**ADDITIONS AND MAJOR RENOVATIONS AT  
HARVARD H. ELLIS TECHNICAL HIGH SCHOOL  
613 UPPER MAPLE STREET  
DANIELSON, CONNECTICUT  
PROJECT BI-RT-841**

<b>BID OPENING</b>	<b>1:00 P.M.</b>	<b>AUGUST 3, 2011</b>
<b>ADDENDUM NUMBER 3</b>	<b>DATE OF ADDENDUM</b>	<b>JULY 25, 2011</b>

Sketch No:  
**ASK-11**  
 BI-RT-841

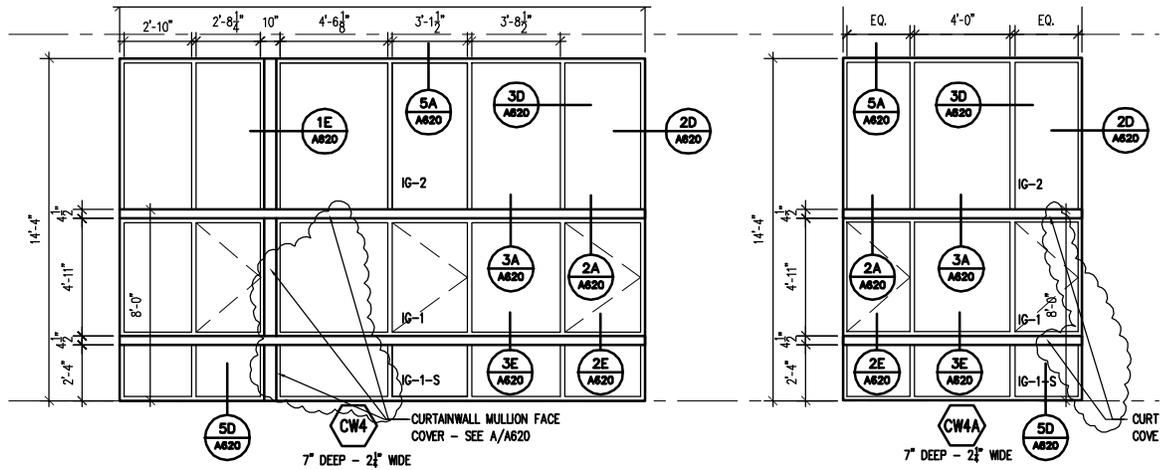
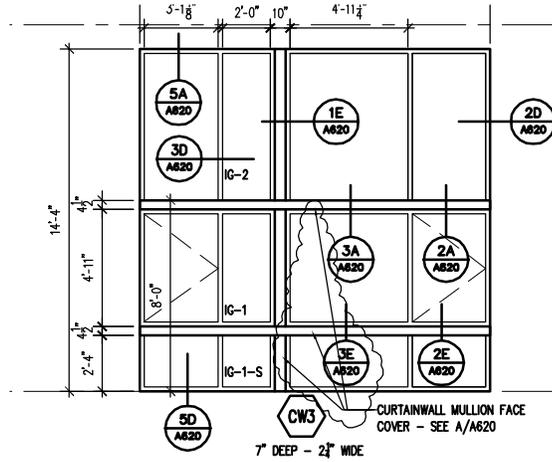
1. Note at Elevation CW5 refers incorrectly to Supplemental Bid #2 – this should be revised to Supplemental Bid #1.
2. **ADD** the following note at CW6: “Note: CW6 is included in Supplemental Bid No. 1”.
3. **CLARIFICATION:** See attached ASK-11. Decorative face cover at aluminum framing to be installed at one vertical and one horizontal mullion on CW8. See attached ASK-12 for similar clarifications regarding face cover locations on CW3, CW4 and CW4A.

CLARIFICATION OF MULLION COVER LOCATIONS

Sketch No.: **SKM-2**  
Revision: **BT-RT-041**

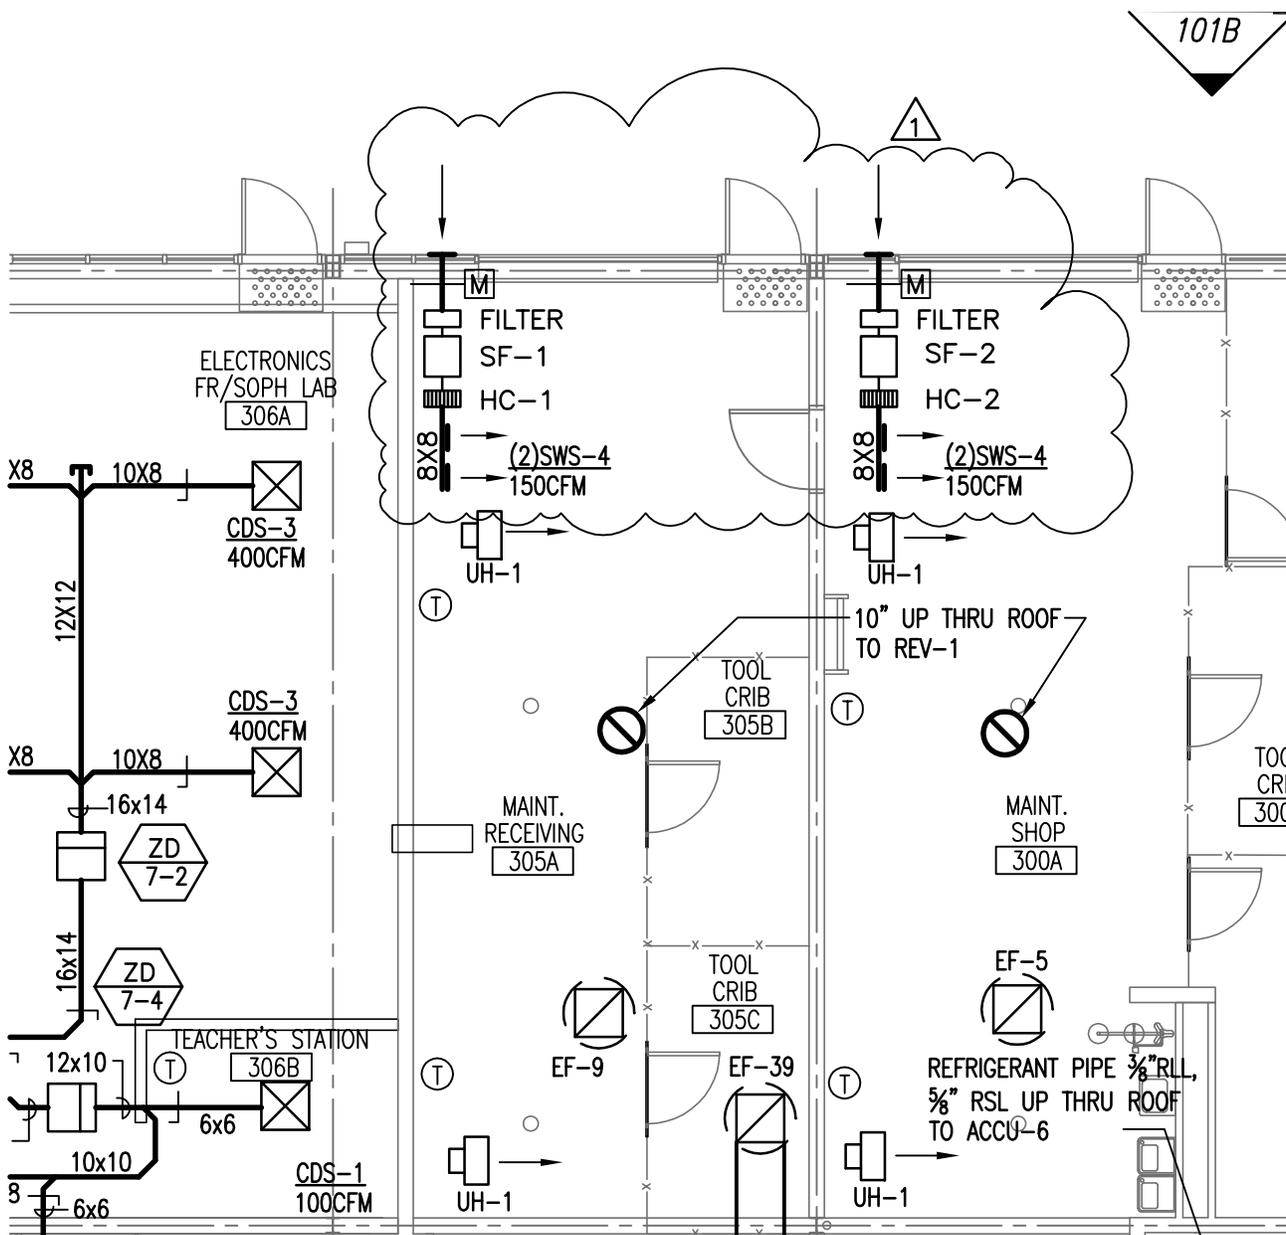
1. See Sketch SKM-2 – “Supply Fans Schedule” – **ADD** and **MODIFY** supply fans SF-1 thru SF-7.

Sketch No:  
**SKM-03**  
**BI-RT-841**

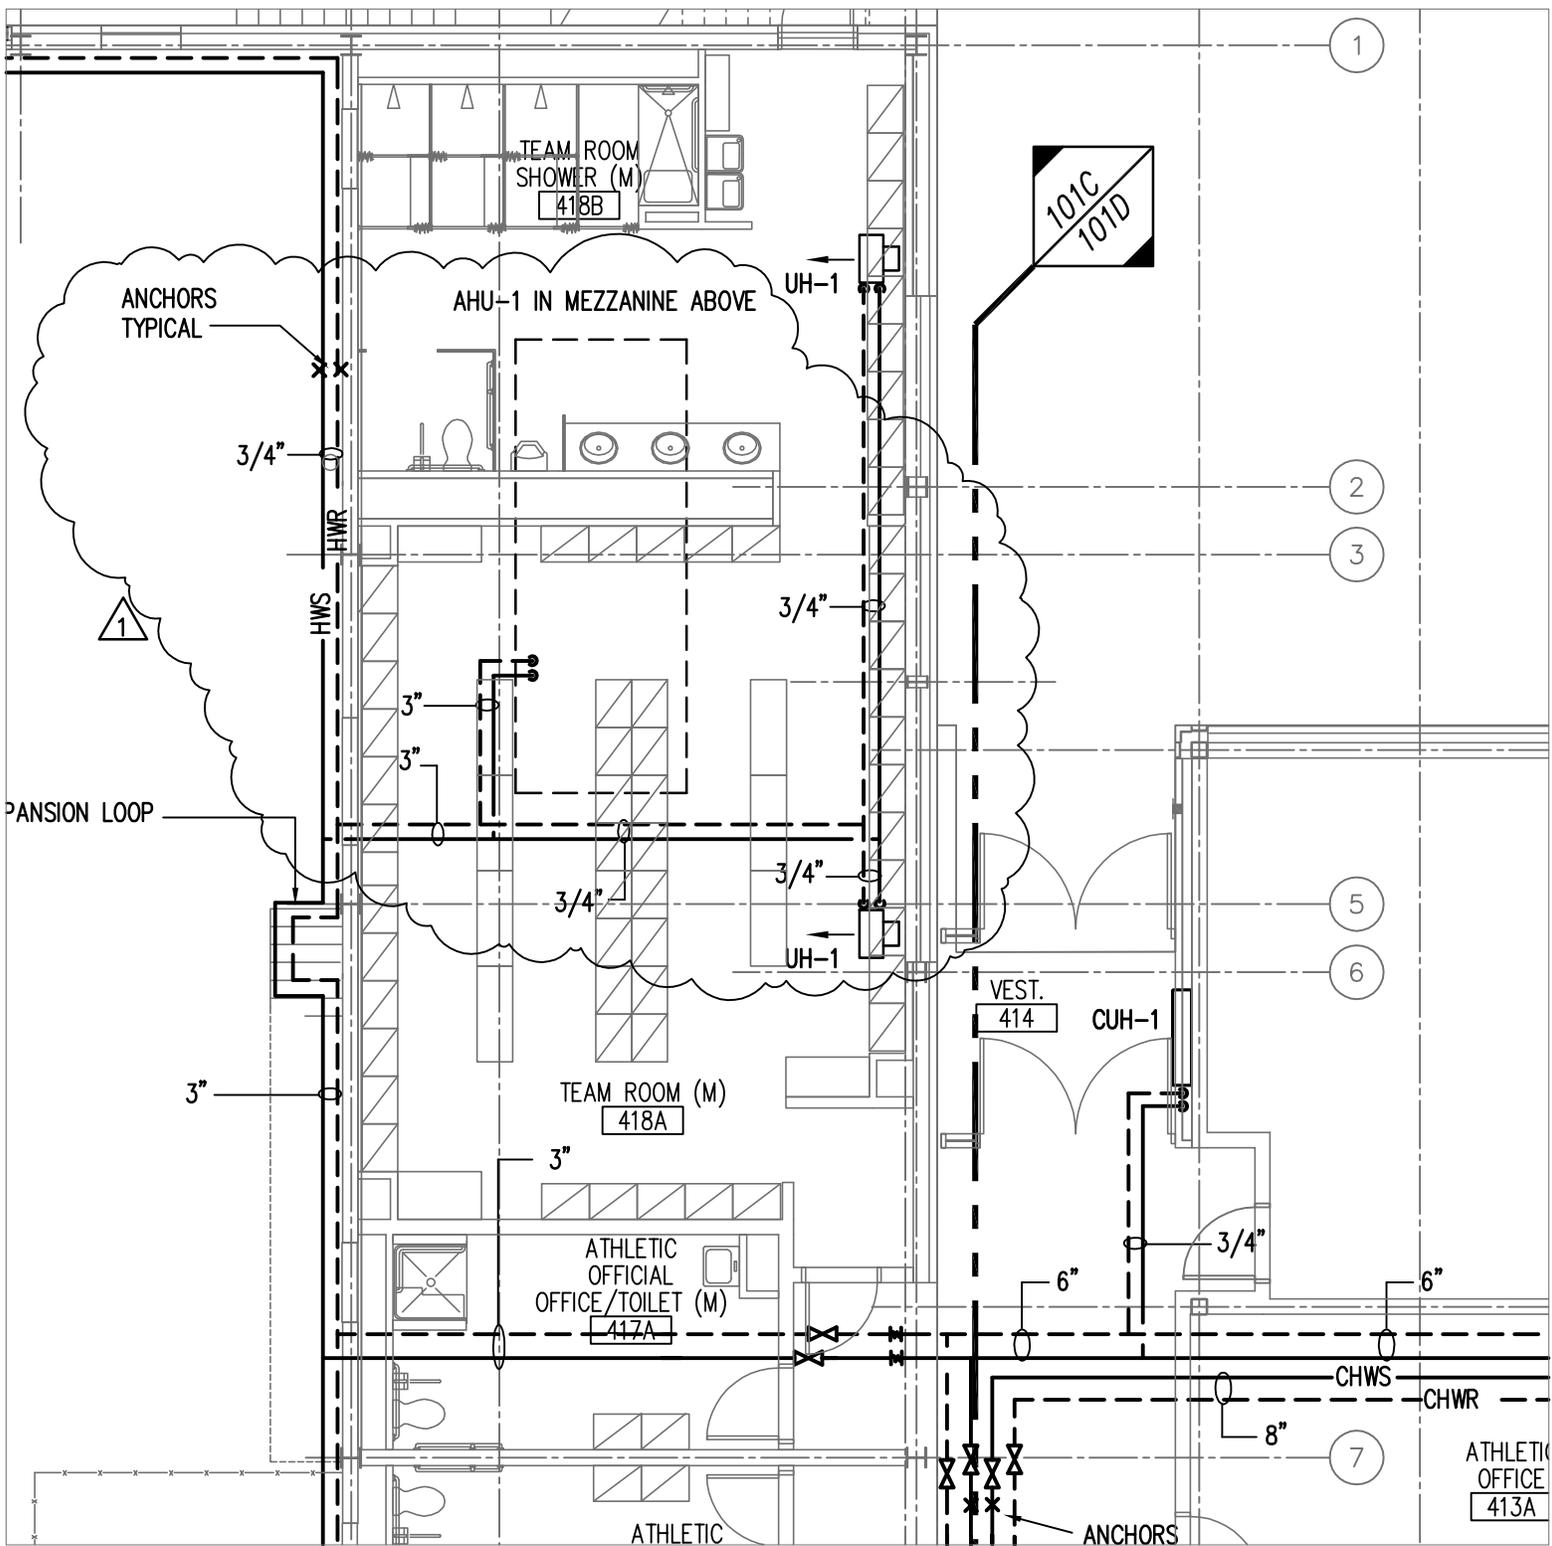
1. See Sketch SKM-3 – “SF-1 and SF-2 Revision”
2. See Sketch SKM-27 – **ADD** tunnel ventilation system SF-3

Sketch No:  
**SKM-04**  
 BI-RT-841

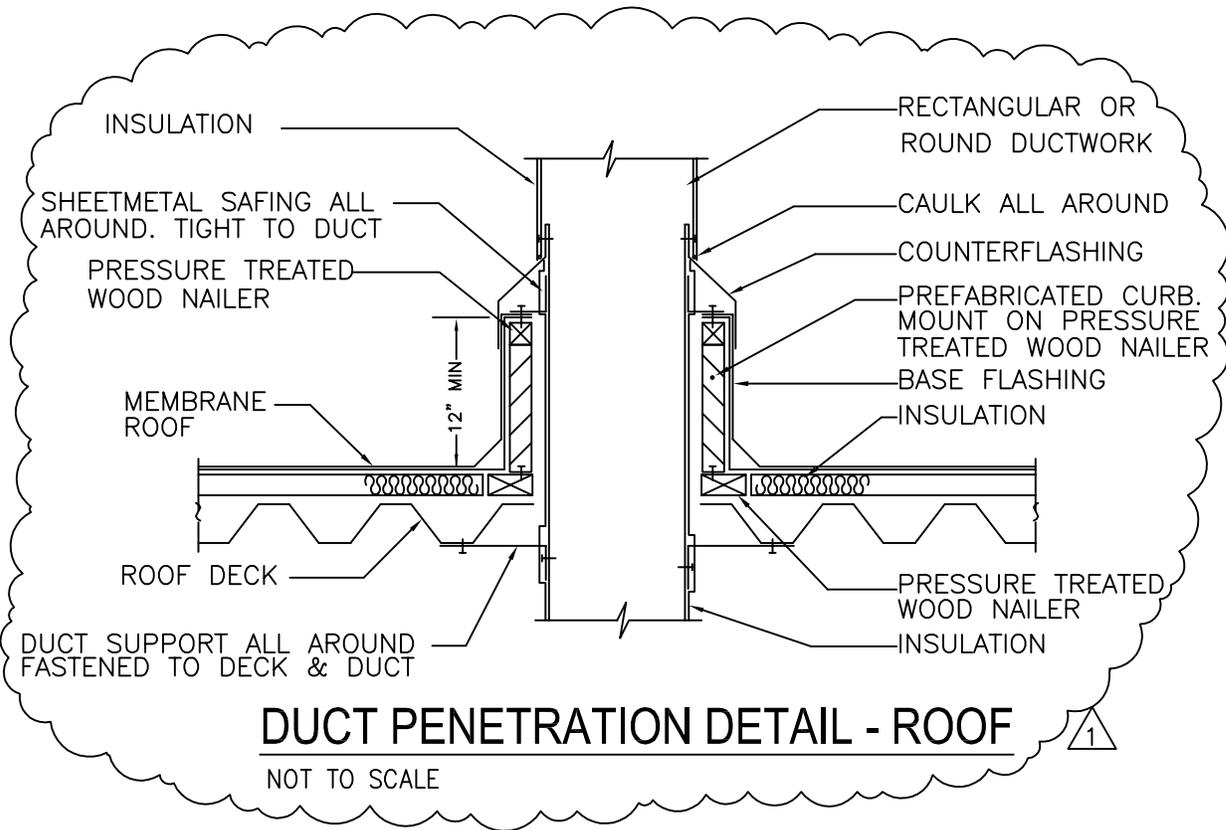
1. See Sketch SKM-4 – “AHU-1 Piping Revision” – **MODIFY** HWS/R pipe branch to unit AHU-1.

Sketch No:  
**SKM-05**

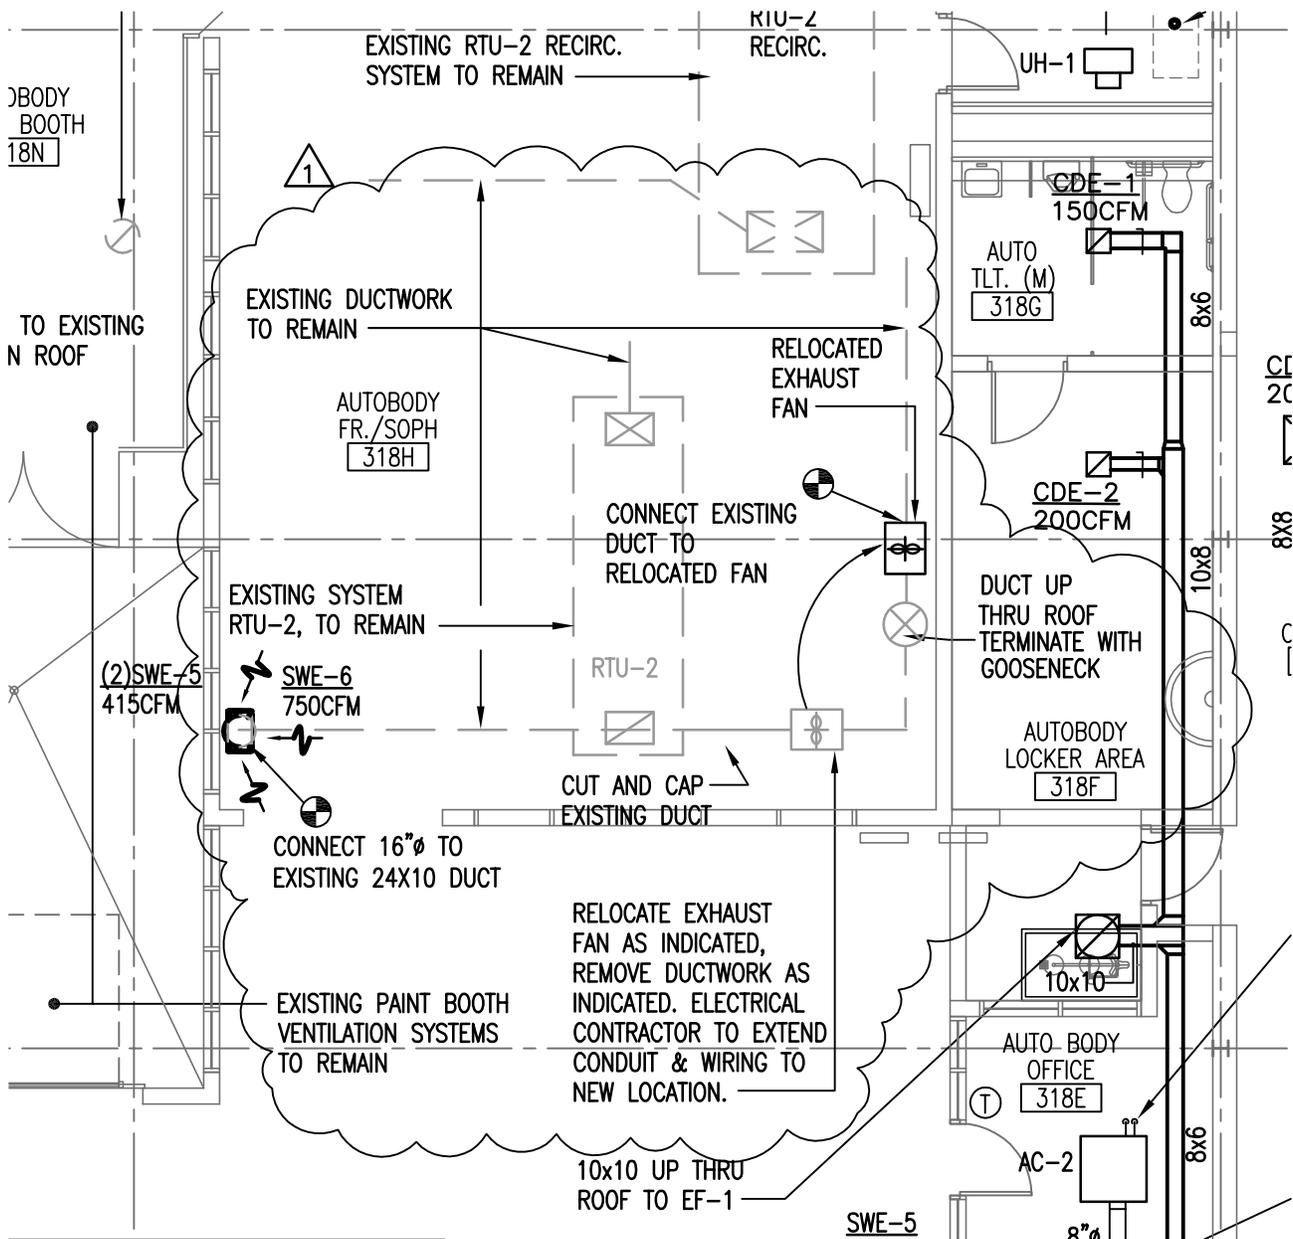
- a. See Sketch SKM-5 – “Duct Penetration Detail” - **ADD** detail

## FIRST FLOOR HVAC DUCTWORK PARTIAL PLAN - PART A

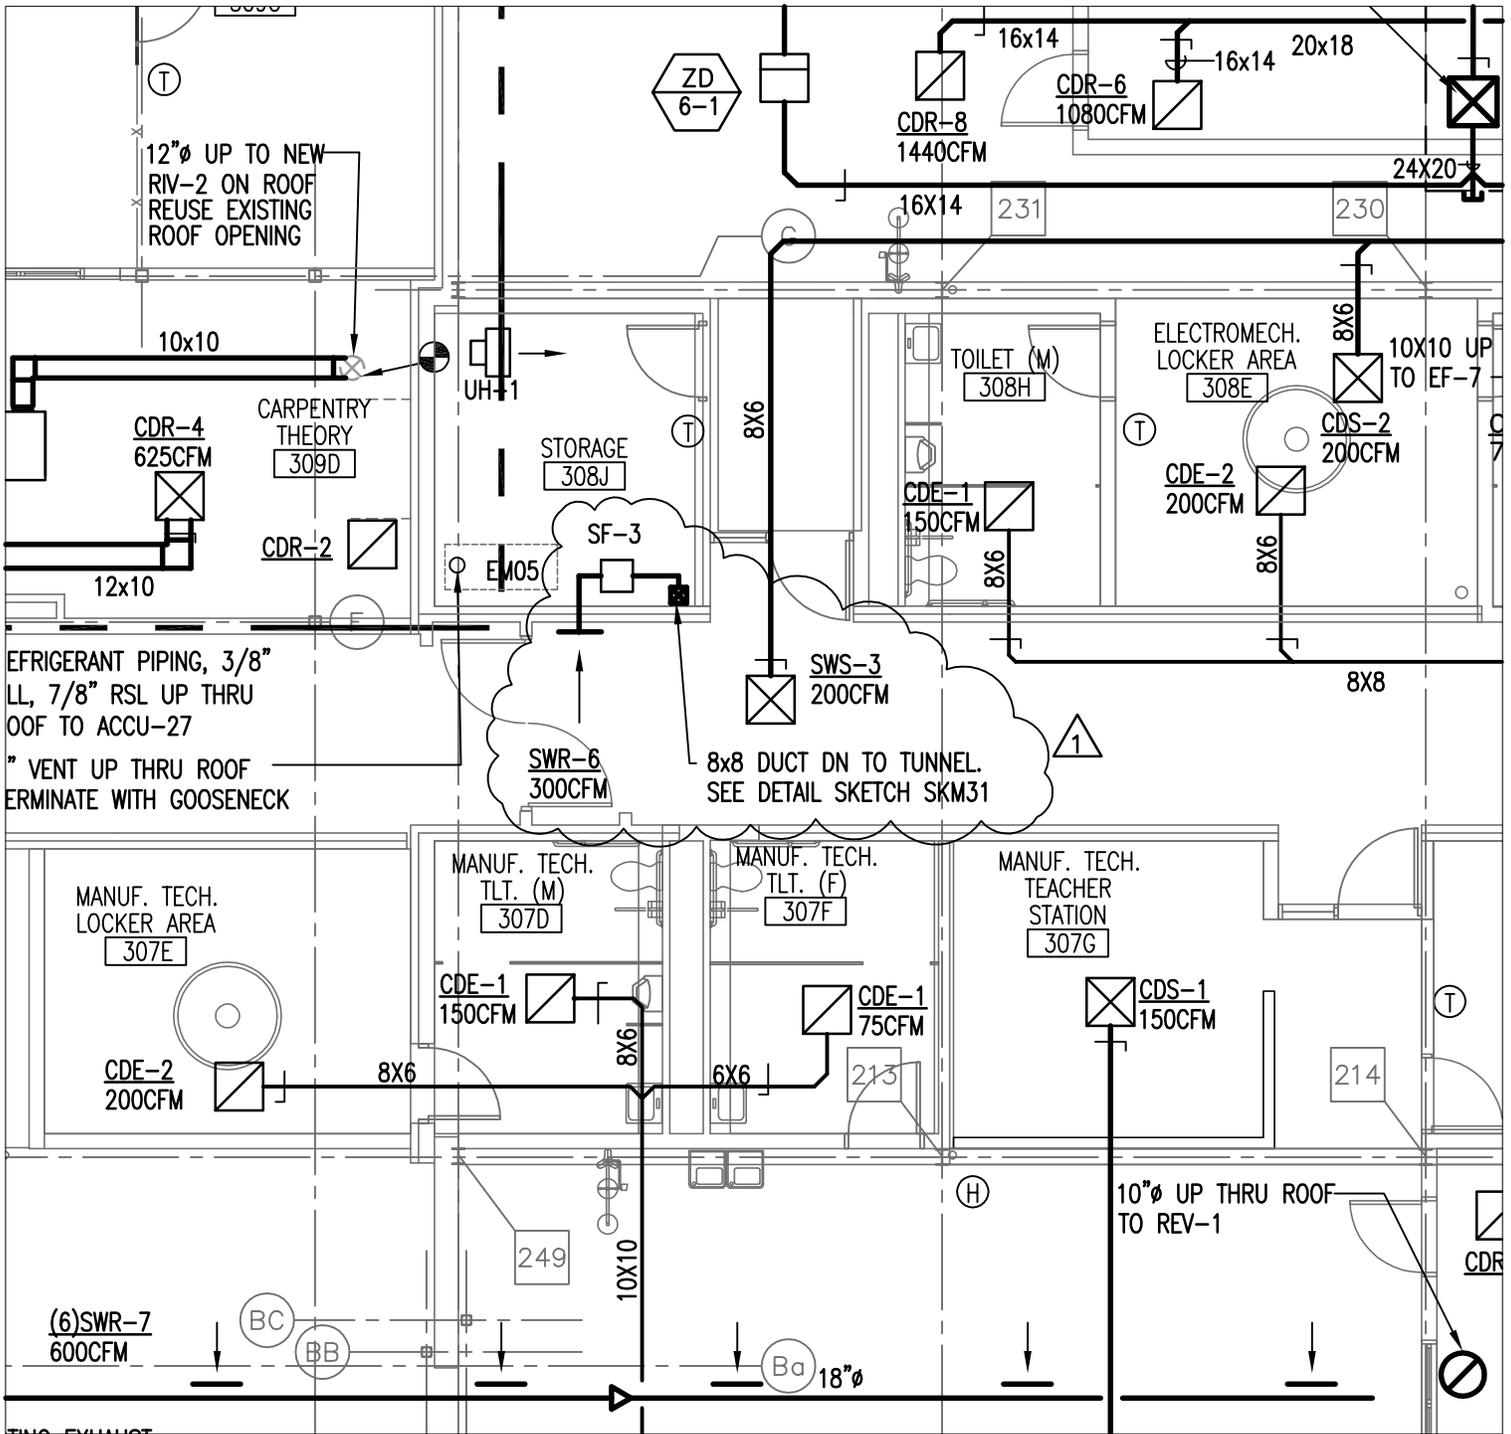
- a. See Sketch SKM-6 – “Existing Exhaust Fan Relocation” – **RELOCATE** existing exhaust fan rm. 318H.

Sketch No:  
**SKM-27**  
 BI-RT-841

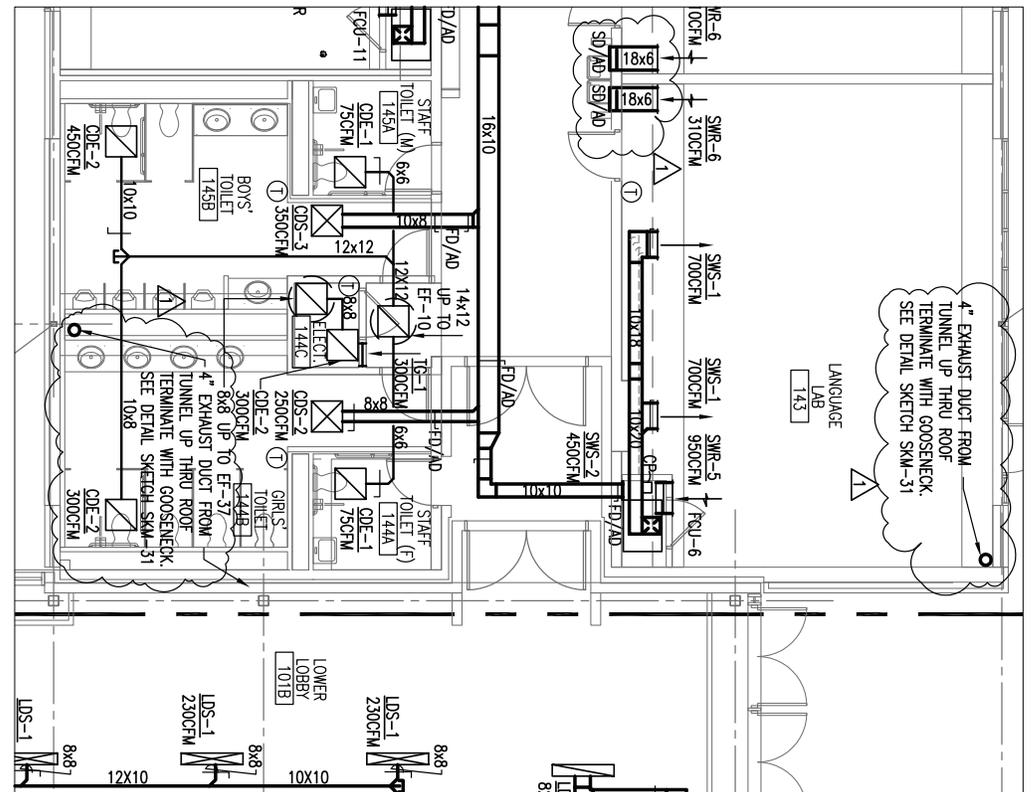
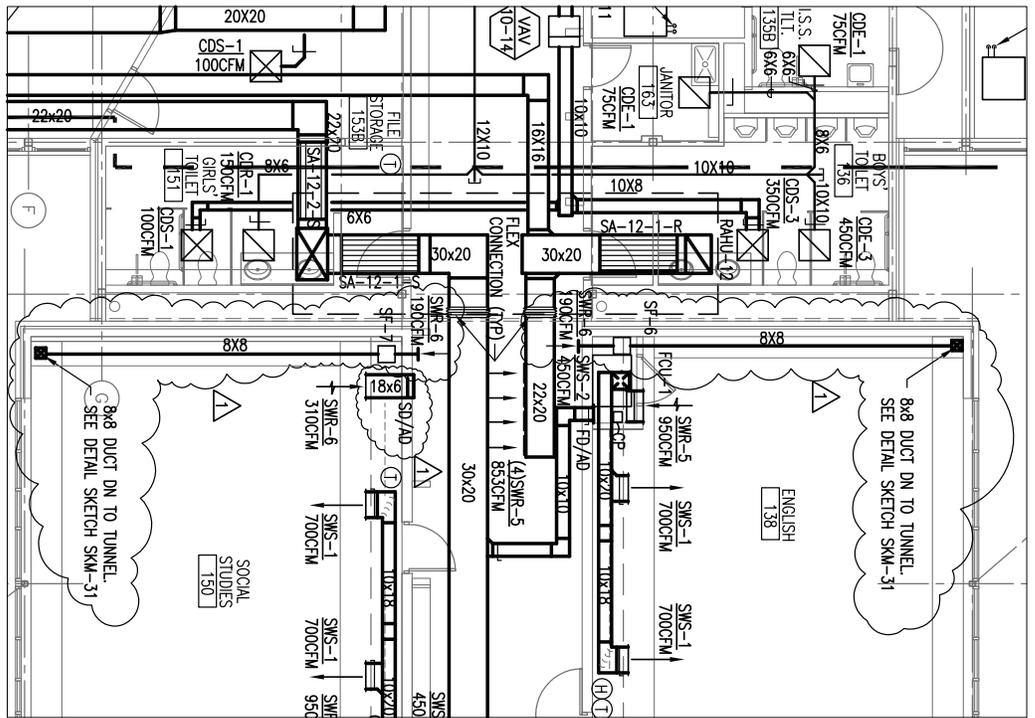
- a. See Sketch SKM-27- **ADD** Tunnel Ventilation Systems
